PREPARED FOR THE PLAN COMMISSION

**Project Address:** 5533 University Avenue (District 19 – Ald. Clear)  
**Application Type:** Demolition and Conditional Use  
**Legistar File ID #:** [49138](#)  
**Prepared By:** Chris Wells, Planning Division  
Report Includes Comments from other City Agencies, as noted  
**Reviewed By:** Kevin Firchow, AICP, Principal Planner

**Image 1: Section Looking Eastward**

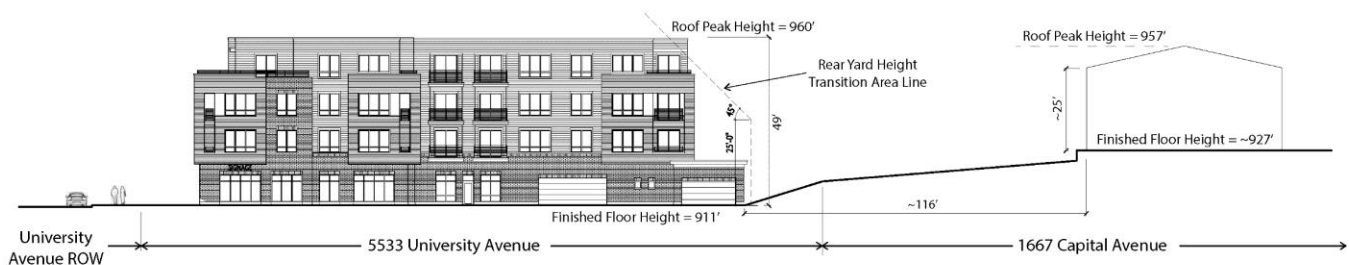
Looking at Image 1 below, one can see the upper right corner of the building (i.e. the southeasterly corner of the building’s fourth floor) extending into the transition area (which is indicated by the angled dashed line). While such a restriction on height transitions is most applicable, and valuable, in infill situations when, for example, a multi-story building is proposed on a block of small and/or narrow lots, for the 5533 University Avenue case, Planning Staff anticipate that that this specific encroachment will not result in significantly different impacts than what would be allowed without the requested conditional use. This is due to the fact that the structures are not only approximately 116 feet away but due to the amount of grade change between properties, the level of the ground floor of the neighboring two-story residential building is roughly 16 feet above that of the subject building.
